STAFF REPORT
KETCHUM PLANNING AND ZONING COMMISSION
REGULAR MEETING OF MARCH 28, 2023

PROJECT: Leadville Trading

FILE NUMBERS: P22-066 and P22-066A

APPLICATION TYPE: Final Design Review and Conditional Use Permit (CUP)

1 PLAN: ROOF
SCALE: 1/4" = 1'-0"

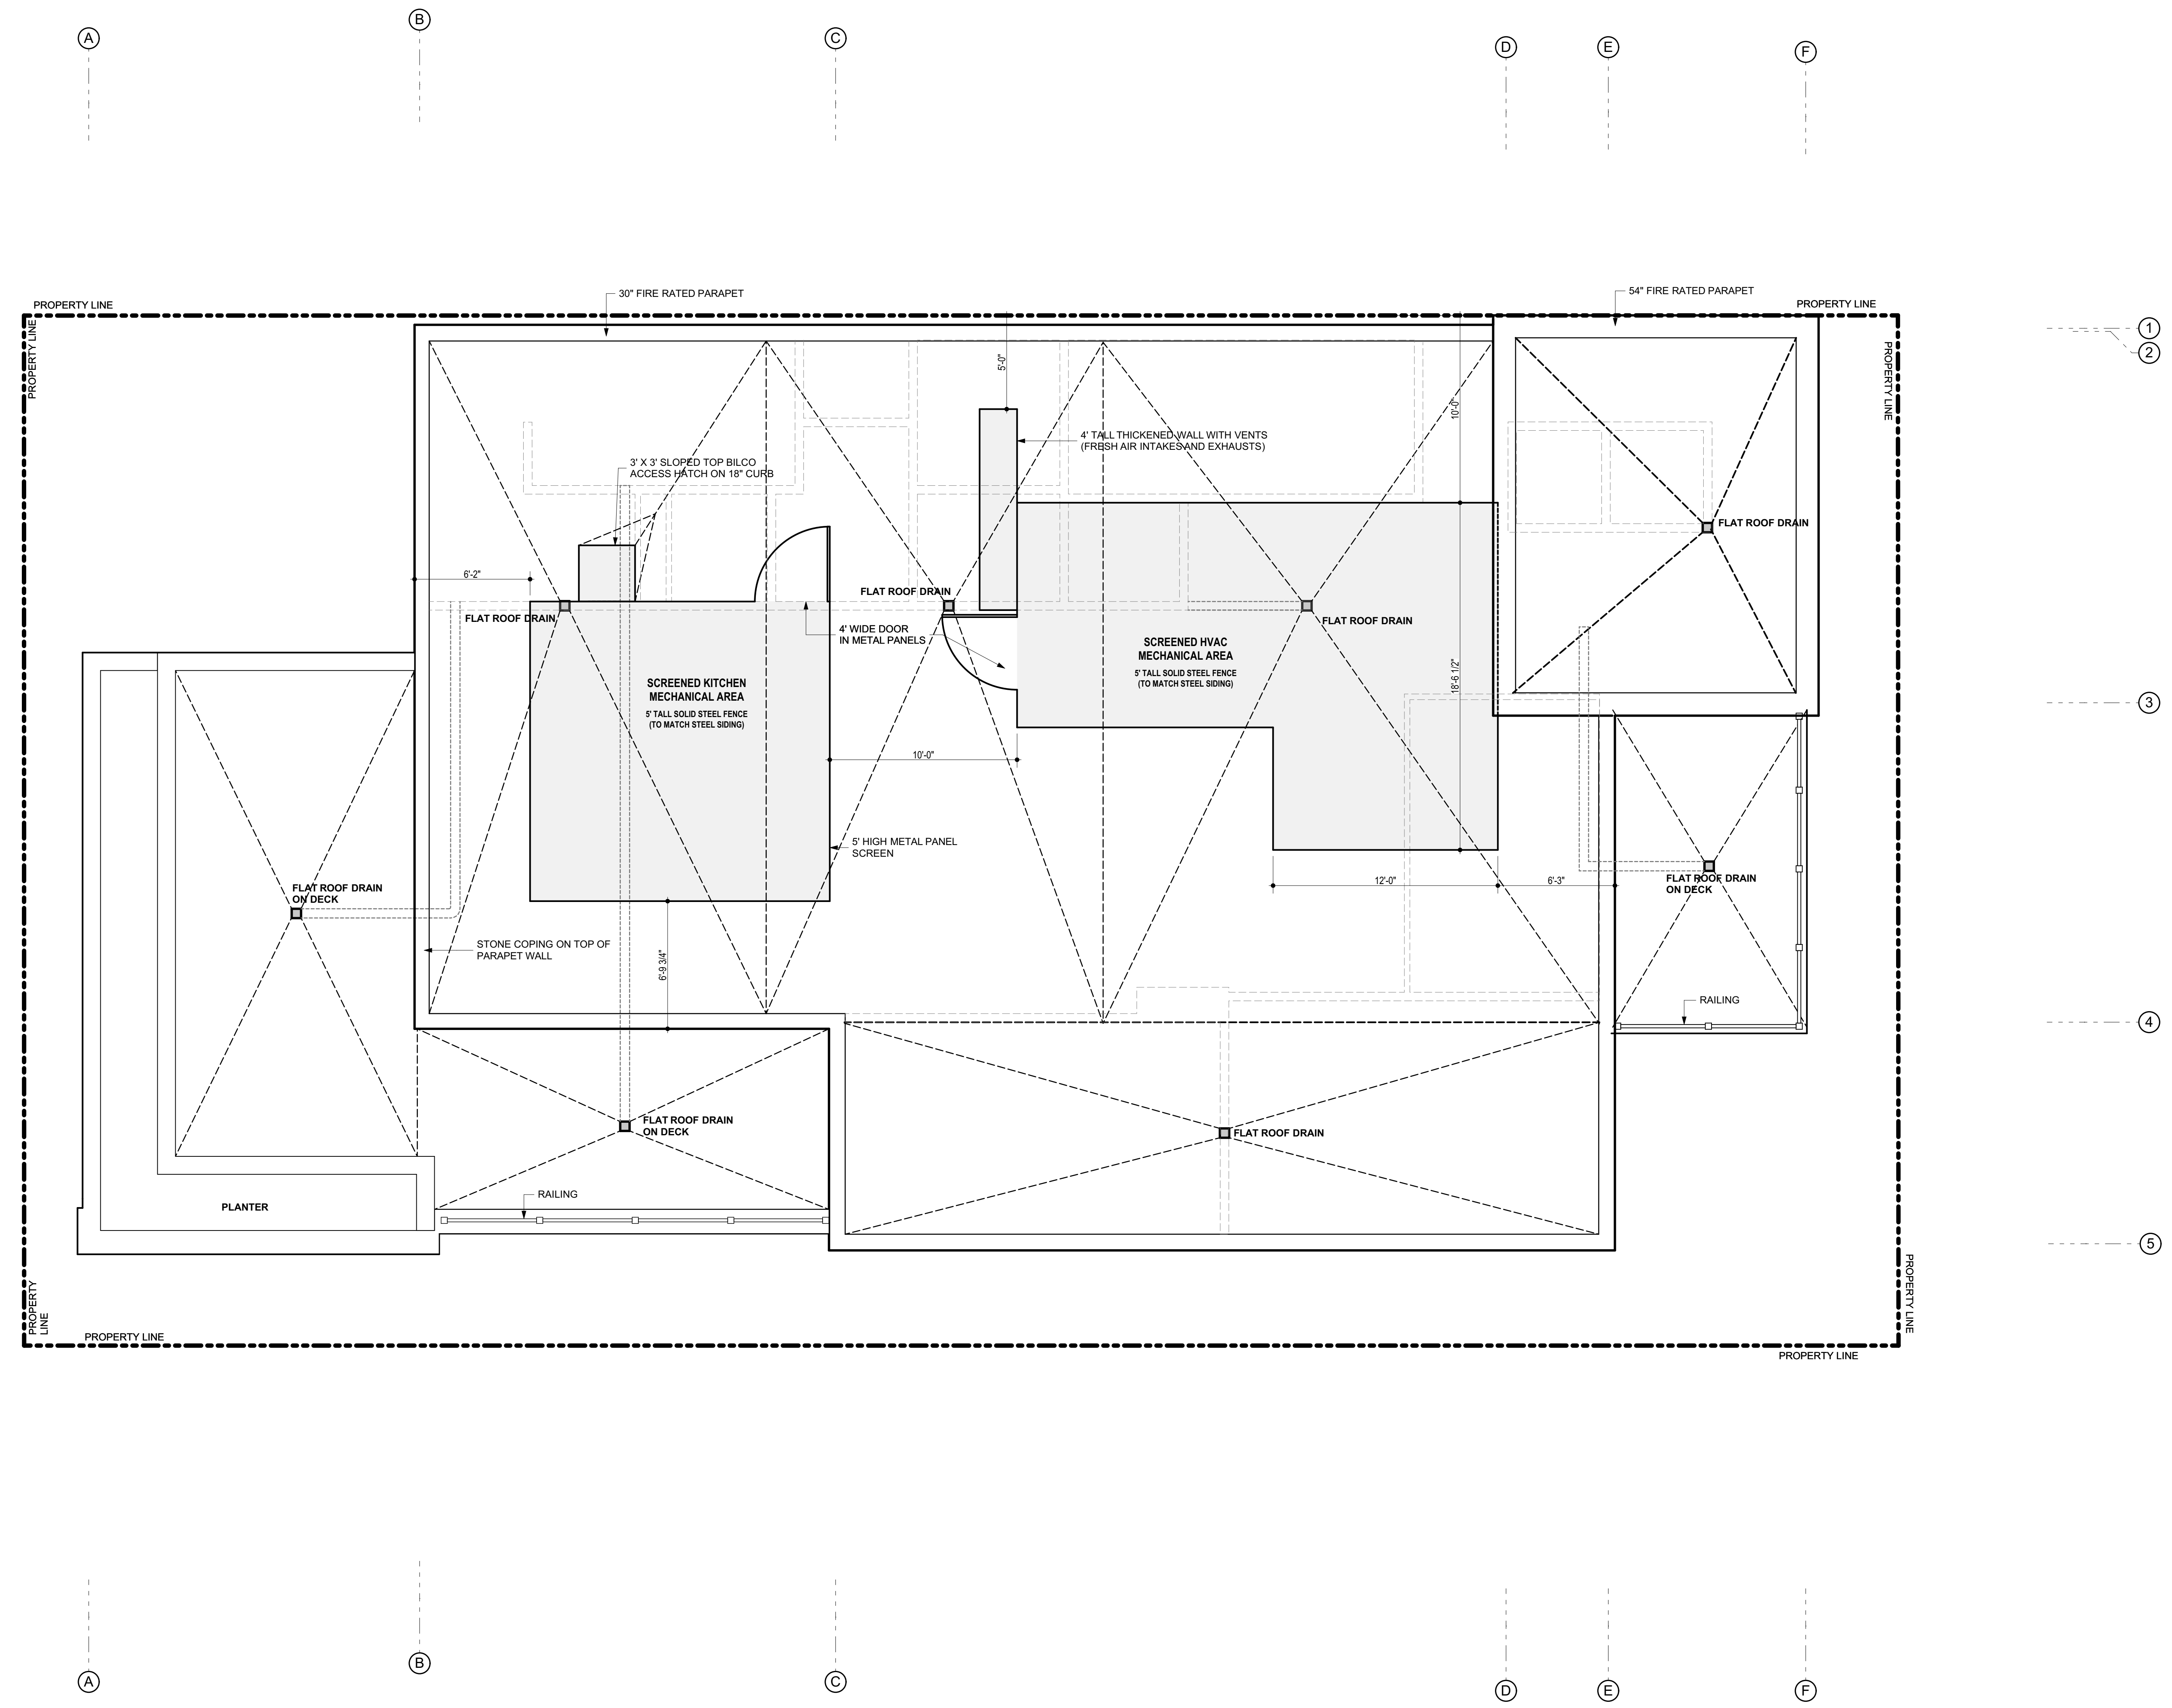
The proposed project meets all the requirements of the zoning regulations except for setbacks of mechanical equipment from building facades. Per KMC 17.12.040, non-habitable structures, fixed amenities, solar and mechanical equipment affixed to a roof must be set back 10 feet from all building facades. As shown on the roof plan (Sheet A2.3), there are two areas designated for mechanical equipment that will be screened with metal paneling at a max height of 5 feet. The mechanical areas proposed vary in setback from 5-10 feet depending on the façade. The applicant has been notified of this issue and fully intends to comply with the code requirements. Staff recommends the applicant revise the roof plan prior to approval of the findings of fact should the project move forward.

Sheet A2.3 shows two areas for the placement of mechanical equipment that does not conform to the setback requirements. Staff recommends a condition of approval that requires the rooftop mechanical systems be revised to meet the code required 10 foot setback from all building facades. This will be required for review and approval prior to building permit issuance.
<input checked="" type="checkbox"/>	<input type="checkbox"/>	<input type="checkbox"/>	17.12.030	<p>Building Height</p> <p>Staff Comments</p> <p>Permitted: 42 feet</p> <p>Height of building/CC District: The greatest vertical distance of a building in the community core district measured by determining the average elevation of the front property line and rear property line. Draw a line from the average front or rear elevation up to the maximum building height allowed, and then draw a line at that height parallel to the front or rear property line. The resulting line establishes the highest elevation of the front or rear facade. The front or rear facade shall not extend above this line. Side facades may be stepped up or down to transition from the highest elevation of the front facade height to the highest elevation of the rear facade. One or multiple steps along the side facades are allowed, except no step shall occur within 40 feet of the front elevation or within 35 feet of the rear facade. The City shall establish the elevation points used to calculate the average elevation of the front and rear property lines (see illustration A on file in the office of the City Clerk).</p> <p>Cantilevered decks and overhangs: 8 feet above walking surface Non-habitable structures located on building roof tops: 10 feet max Perimeter walls enclosing roof top deck and structures: 4 feet above roof surface height Roof top solar and mechanical equipment above roof surface: 5 feet</p> <p>Proposed:</p> <p>As shown on Sheets A3.0 and A3.1, the total building height in the rear (alley) is 30 feet. The total building height in the front (Leadville side) is 32 feet.</p> <p>Cantilevered decks and overhangs: The cantilevered deck on the Leadville Ave side is 10.5 feet from the walking surface. Non-habitable structures located on building roof tops: n/a – there are no structures on building rooftops proposed for the project. Perimeter walls enclosing roof top deck and structures: n/a - there are no roof top deck or structures</p>

2 ELEVATION: NORTH
SCALE: 1/4" = 1'-0"

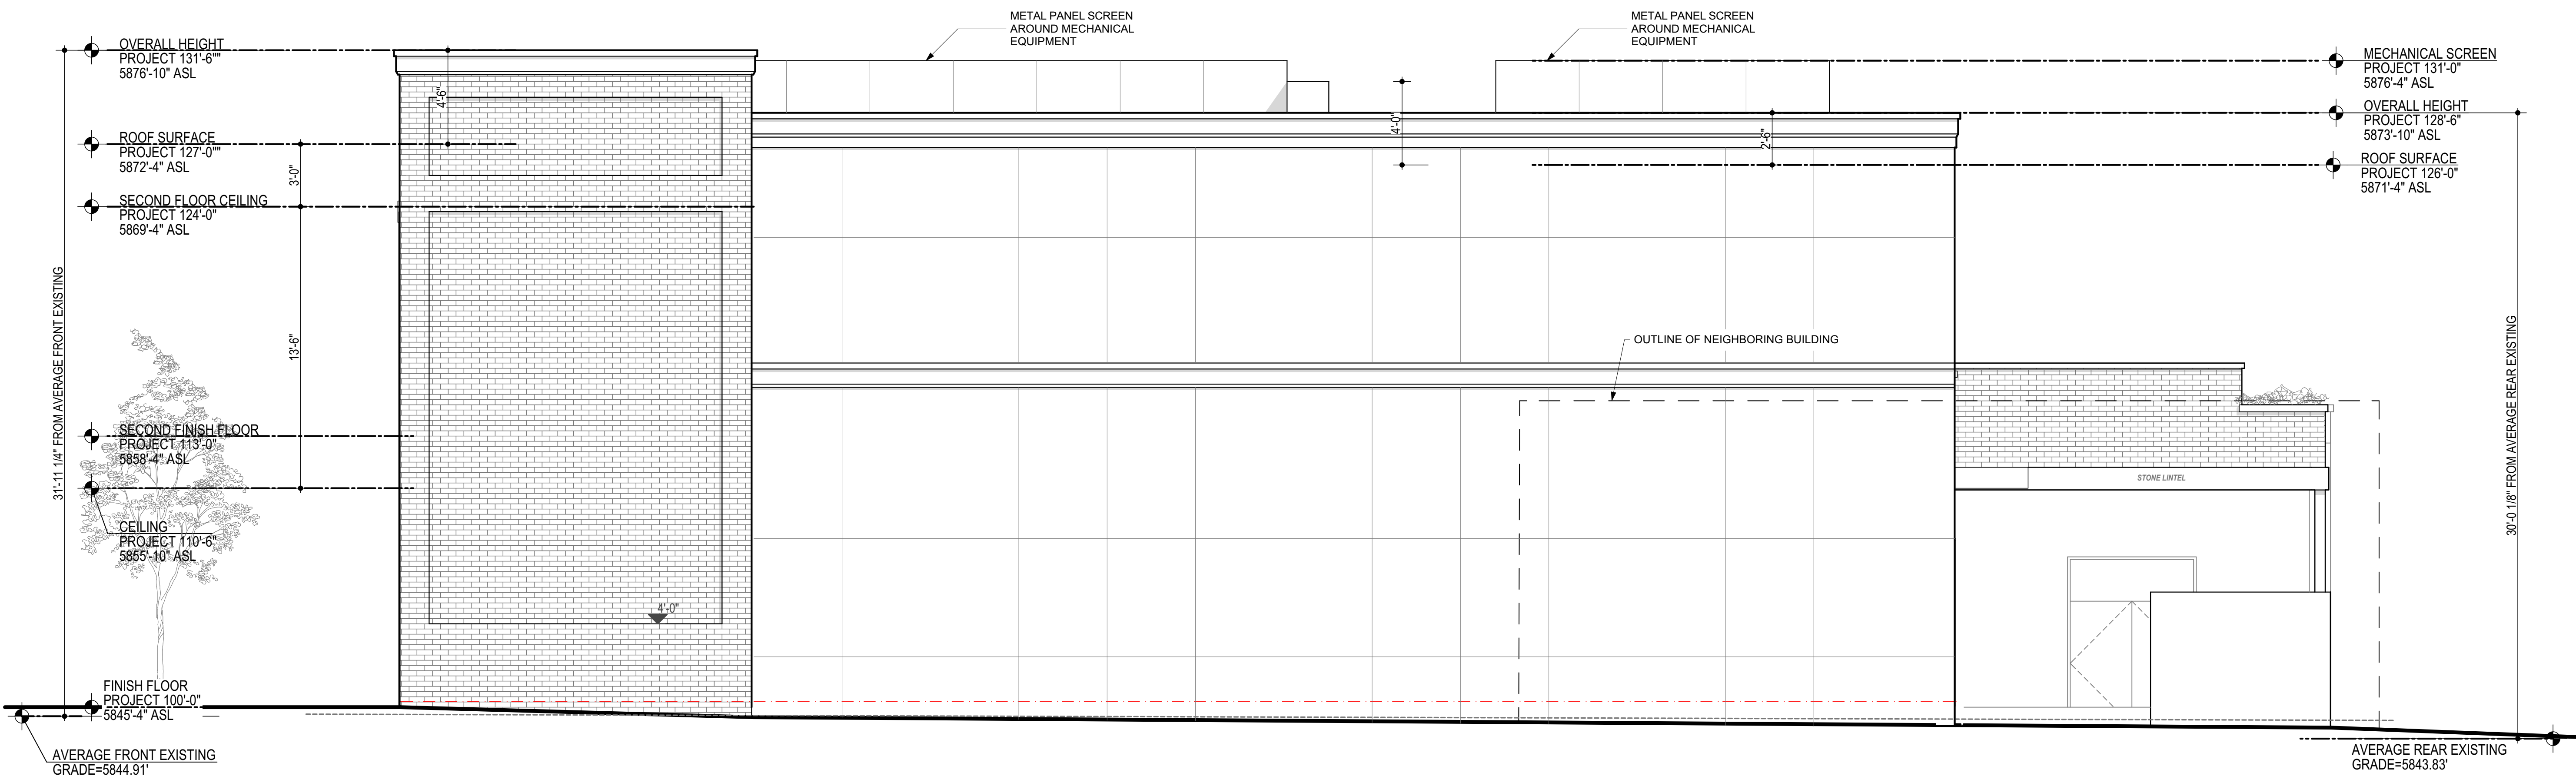
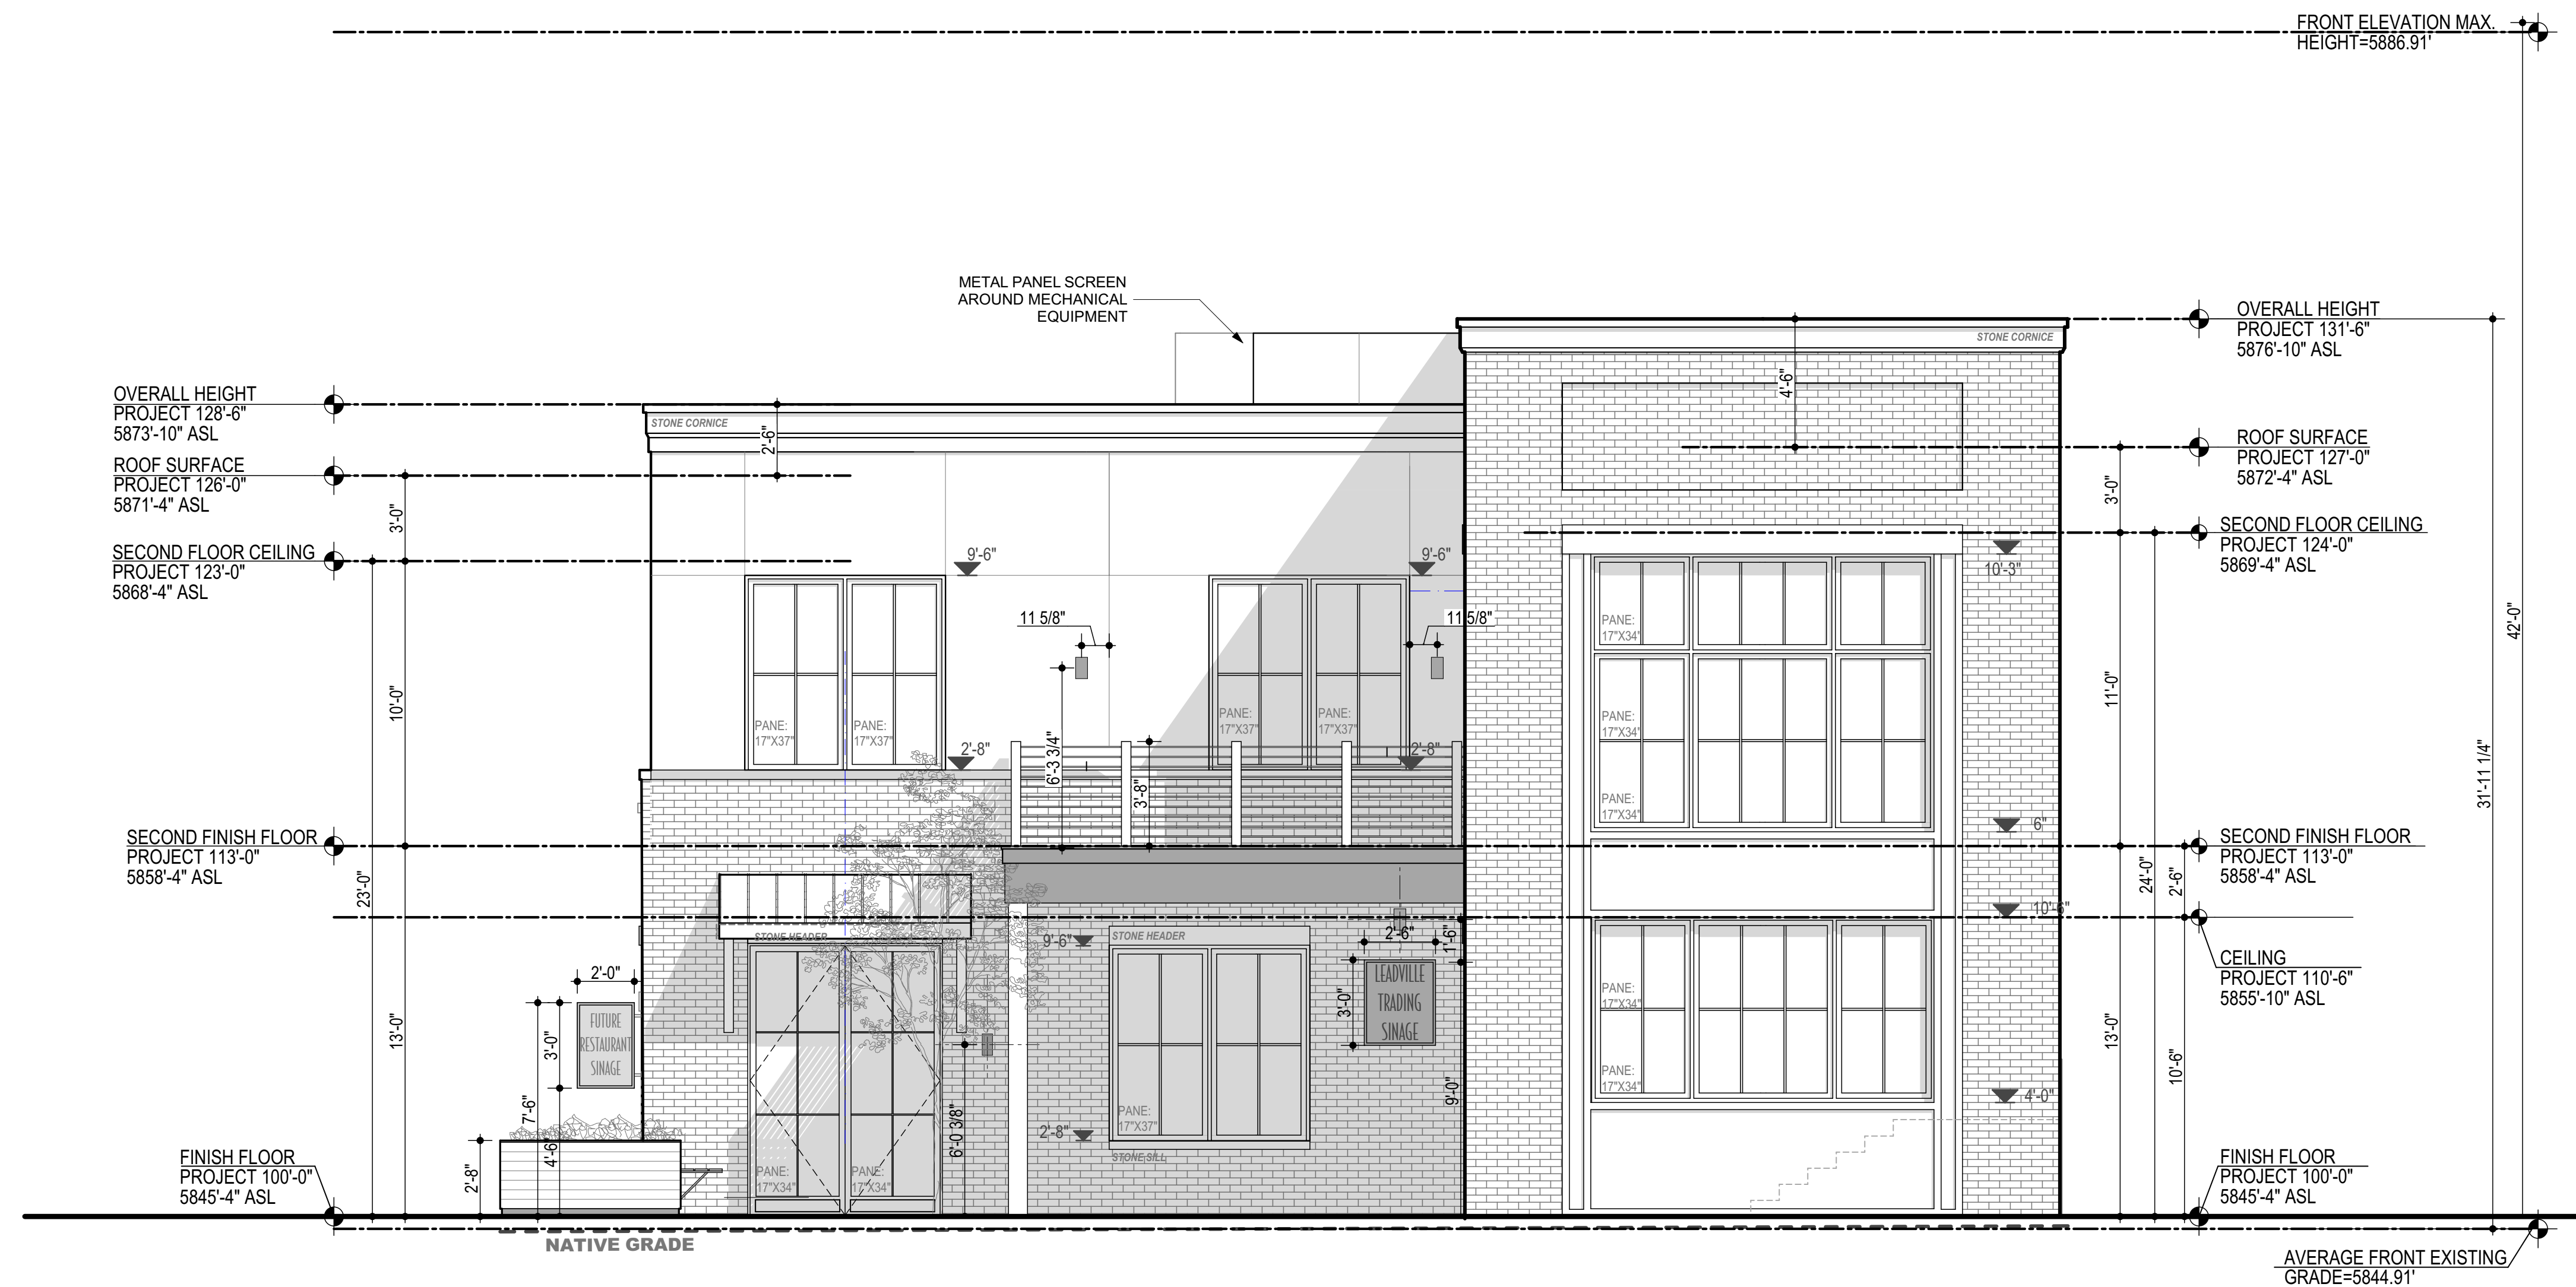
Design review criteria F.5 states that “Building walls shall provide undulation/relief, thus reducing the appearance of bulk and flatness”. As shown on Sheet A3.2, the building provides undulation and relief in multiple areas. The most prominent being the staggering of the building façade on the Leadville Ave side of the building. The north end of the façade is set back 4.5 feet where the south end of the façade (towards the corner) is set back 15 feet. This is further accentuated by the inclusion of a cantilevered balcony on the Leadville Ave side. On the 2nd Street side, the building is set back a consistent 5 feet, however, there is a recessed entrance to the building that provides relief at the ground level. Additionally, the west end of the second floor is set back significantly to accommodate a second level balcony. Due to the size of the setback, this portion of the building feels much like a one-story building from the pedestrian level.

The north façade is one portion of the building is an area of discussion. As shown on the south elevation of the building on Sheet A3.1, the north façade of the building has a zero-foot setback and contains some relief provided by recessed brick elements and horizontal banding. The elevation also shows the outline of the adjacent building, Vintage Restaurant. The corner is more prominent as the proposed material wrapping the corner is brick, however, the materials quickly shift to bronze metal paneling for the remainder of the facade. This surface appears very flat and much of the building is exposed due to the size of the adjacent historic structure. As noted above, the height of the building is 30 feet in the rear and 32 feet at N Leadville Ave.

As shown in Figure 2, Vintage is set back towards the rear of the property with surface parking in the front portion of the property. The applicant has represented that they are working with the restaurant owners and local artists for an art installation on the wall that will reduce the perceived flatness of the building.

17.96.060.F.5 – Architectural	Conformance
<i>Building walls shall provide undulation/relief, thus reducing the appearance of bulk and flatness.</i>	NO

Finding: As shown on Sheet A3.2, the building provides undulation and relief in multiple areas. The most prominent being the staggering of the building façade on the Leadville Ave side of the building. The north end of the façade is set back 4.5 feet where the south end of the façade (towards the corner) is set back 15 feet. This is further accentuated by the inclusion of a cantilevered balcony on the Leadville Ave side. On the 2nd Street side, the building is set back a consistent 5 feet, however, there is a recessed entrance to the building that provides relief at the ground level. Additionally, the west end of the second floor is set back significantly to accommodate a second level balcony. Due to the size of the setback, this portion of the building feels much like a one story building from the pedestrian level. The north façade is one portion of the building that staff has concerns. As shown on the south elevation of Sheet A3.1, the north façade of the building has a zero-foot setback and contains minimal relief. The corner is more prominent as the proposed material wrapping the corner is brick, however, the materials quickly shift to bronze metal paneling. This surface appears very flat and much of the building is exposed due to the size of the adjacent historic structure. The elevation on Sheet A3.1 shows the outline of the adjacent building, Vintage Restaurant.
